NUMBER: S.I. M20-59A

SUBJECT: M20J AND M20K, IMPROVEMENT IN STARTING; REMOVAL OF GROUNDING STRAP FROM MAGNETO SWITCH

MODELS/ S/N's AFFECTED: Mooney M20J S/N 24-0001 thru 24-1325 M20K S/N 25-0001 thru 25-0710

FIGURE 1

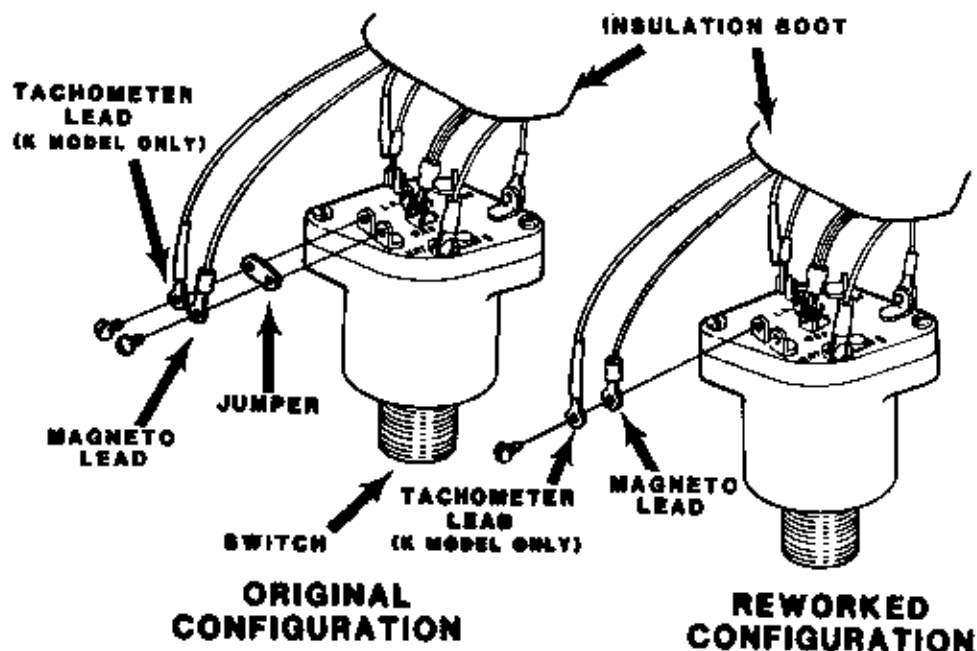
5. Locate right magneto terminal "R" on rear of magneto switch assembly (See Fig. 1) that has jumper strap to secondary ground terminal.
6. Loosen the terminal screws from the secondary ground and the "R" terminals and remove the jumper strap from between the two terminals.

7. Reconnect wire (M20J) or wires (M20K) to the "R" terminal of the magneto switch assembly and tighten screws securely. Be sure the wires are connected to the "R" terminal now that the jumper has been removed.

REVISION A - Corrected printing error of wiring connection on switch, does not affect intent of S.I. All aircraft are wired correctly, except for jumper modification.
